## SLIDE-OUTS

### Purpose

This document is for identifying the differences between the standard (Fig. 1) and inverted (Fig. 2) gear racks of an In-wall Slide-out system.

Fig. 1

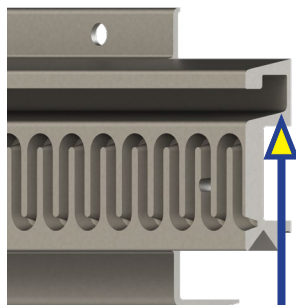
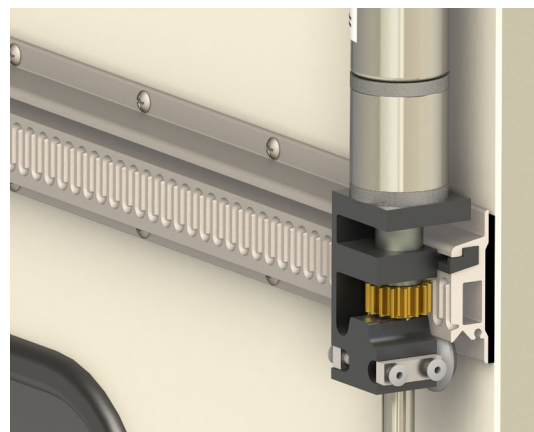
Starting March 2019, all In-wall systems were manufactured with the inverted gear rack system. There are specific repair kits available for the Standard and Inverted gear rack systems.

Inverted design allows for better water deflection.

If an entire standard system needs to be changed out, it will be replaced by an inverted system, but repair kits for the standard system will still be available.
